SERVICE BULLETIN REVISION TRANSMITTAL SHEET

TITLE: AIR CONDITIONING - AIR COOLING - INSTALL IMPROVED RAM AIR OUTLET (RAO)

MODIFICATION No.: 34651K9631

This page transmits Revision No. 01 of Service Bulletin No. A320-21-1150.

Figure 4, Sheet 1
Replacement of the Ram Air-Outlets LH and RH

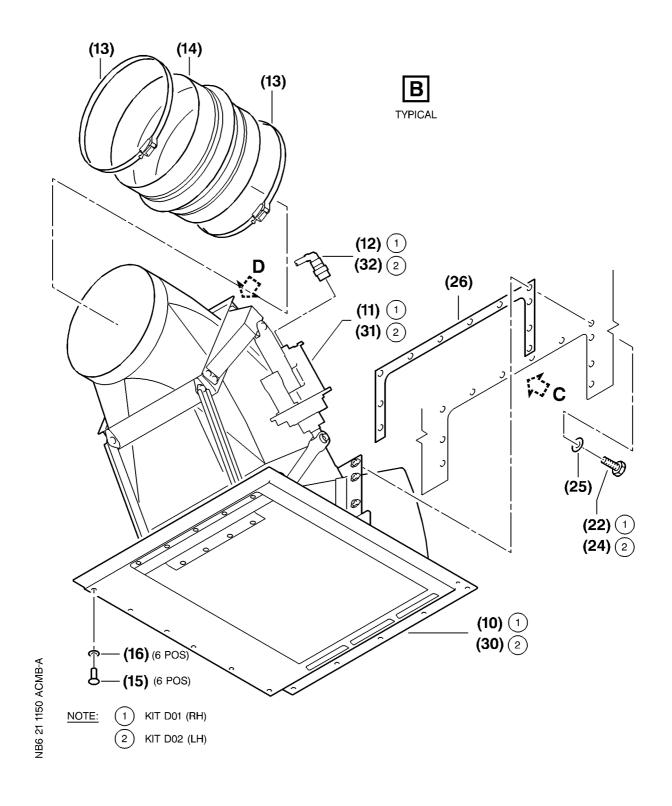
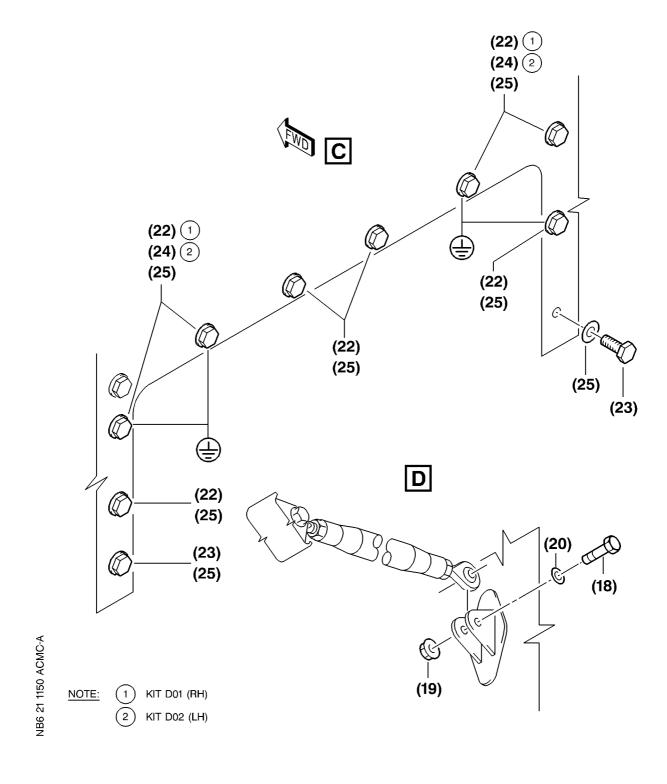
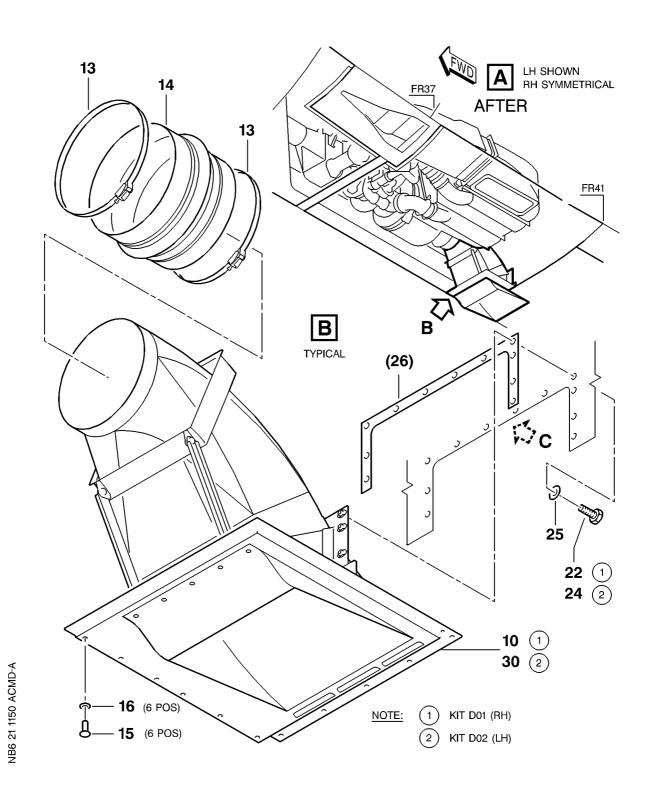
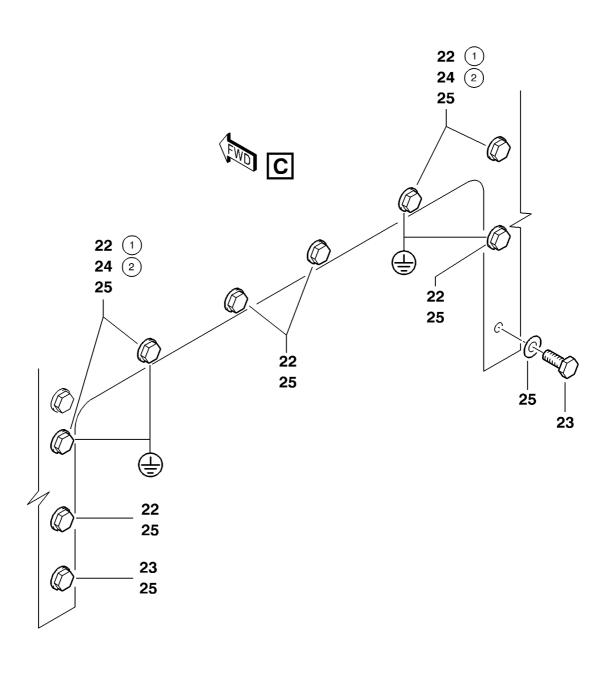
Some operators have reported excessive play in the ram air-outlet assembly. In some cases, excessive play of the ram air-outlet assembly has resulted in loud noises and vibrations audible in aircraft during flight.

This Service Bulletin details the removal of the ram air-outlet assembly with movable parts and the installation of a air-outlet assembly without movable parts.

(a)			e the RH ra Figure 4	m air outlet			
	<u>1</u>				actuator 29HH, item (ure 4, Sheet 2, Detail I		ical plug
	<u>2</u>		sen from thail B:	ne input side of th	ne bellow, item (14), re	efer to Figure 4	, Sheet 2,
		l	clamp			Item (13)	
	<u>3</u>	Rer	move from t	he ram air outlet	RH, item (10), refer to	Figure 4, Shee	et 2, Detail B :
	6		bolt			Item (15)	discard
			washer			Item (16)	discard
	<u>4</u>	Rer	move, refer	to Figure 4, She	et 3, Detail D :		
	,		bolt nut			Item (18) Item (19)	discard discard

1	washer		Item (20)	discard	
CAUTION	I: TO REMOVE THE R SECOND PERSON	AM AIR OUTLET ASS IS NEEDED.	SEMBLY, ITEM	l (10), A	
<u>5</u> Remo	ove, refer to Figure 4, She	eet 2, Detail B and She	eet 3, Detail C	:	
9	bolt		Item (22)	discard	
2	bolt		Item (23)	discard	
11	washer		Item (25)	discard	
and, r	efer to Figure 4, Sheet 2	P, Detail B:			
1	air-outlet assy		Item (10)	See NOTE	
1	actuator		Item (11)	discard	
2	clamp		Item (13)	discard	
1	bellow		Item (14)	discard	
1	seal		Item (26)	retain	
Install the	NOTE: The removed ram air-outlet assembly, item (10), consist of one of these alternative PNs: - D2157108001000 or - D2157108001400 or - D2157108001800 or - D2157108002000 or - D2157108002200 or - D2157108002400 Install the improved RH ram air outlet Refer to Figure 4				
CAUTION	I: TO INSTALL THE RA	AM AIR OUTLET ASS IS NEEDED.	EMBLY, ITEM	10, A	
1 Install	l, refer to Figure 4, Sheet	t 4, Detail B and Sheet	5, Detail C:

- (3) Kit 211150D02R00
 - (a) Remove the LH ram air outlet Refer to Figure 4
 - 1 Remove from the air outlet flap actuator 9HH, item (31), the electrical plug 9HH-A, item (32), refer to Figure 4, Sheet 2, Detail B:
 - 2 Loosen from the input side of bellow, item (14), refer to Figure 4, Sheet 2, Detail B.
 - 1 clamp ltem (13)
 - 3 Remove from the ram air outlet LH, item (30), refer to Figure 4, Sheet 2, Detail B:

Figure 5, Sheet 1 Installation of Stowage Brackets for Electrical Plugs 9HH-A and 29HH-A

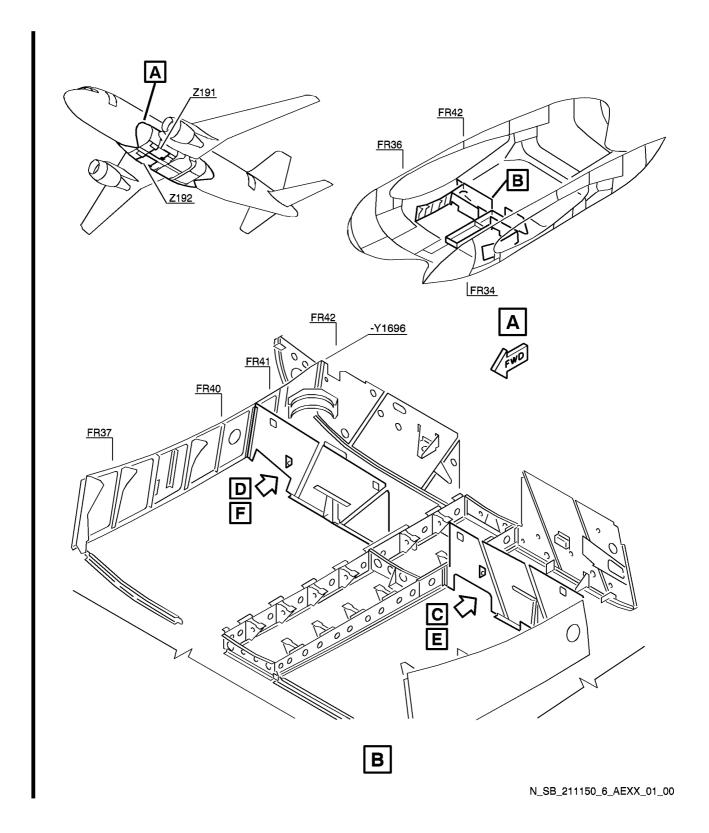
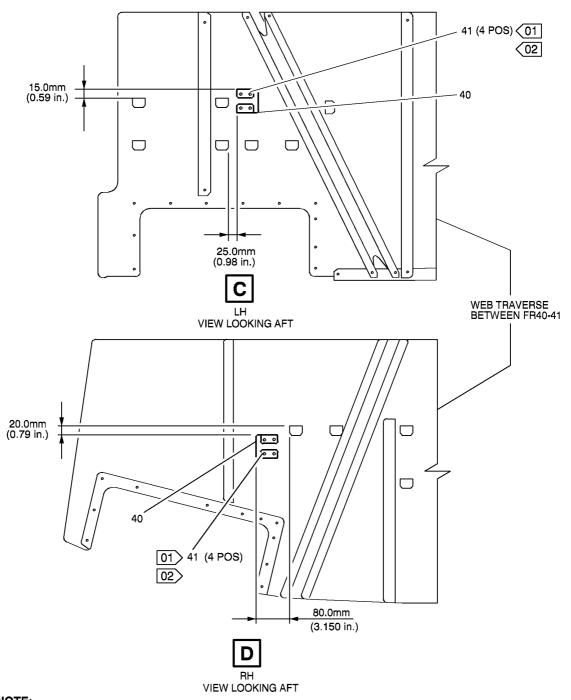
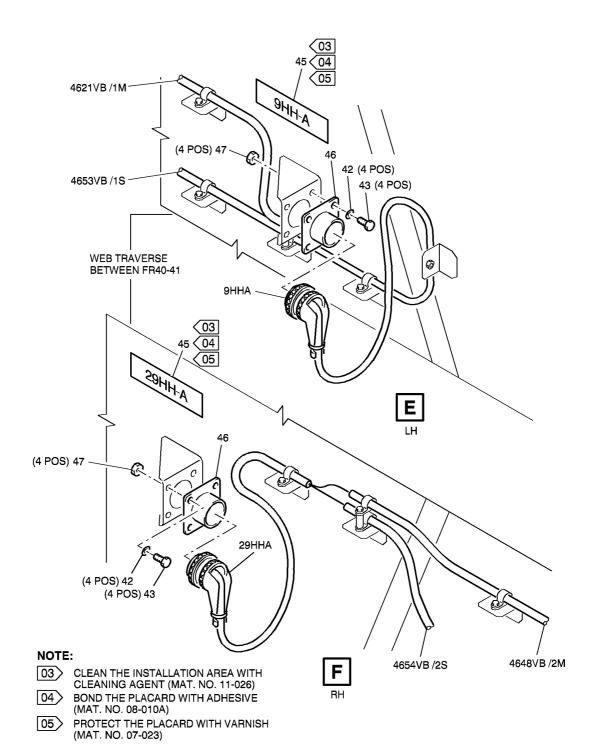
- . 3.C. Test updated.
- Figure 5
 - . Sheets 1 thru 3 revised.

- (4) Kit 211150D03R00 Refer to Figure 5 Refer to Figure 6 (Wiring)
 - (a) Install the stowage bracket for the electrical plug 9HH-A.
 - 1 Put this item into position at the front side of the web traverse between FR40 LH and FR41 LH and transfer drill the four attachment holes, as shown in Figure 5, Sheet 2, Detail C.

- (c) Install the stowage bracket for the electrical plug 29HH-A.
 - Put this item into position at the front side of the web traverse between FR40 RH and FR41 RH and transfer drill the four attachment holes, as shown in Figure 5, Sheet 2, Detail D.
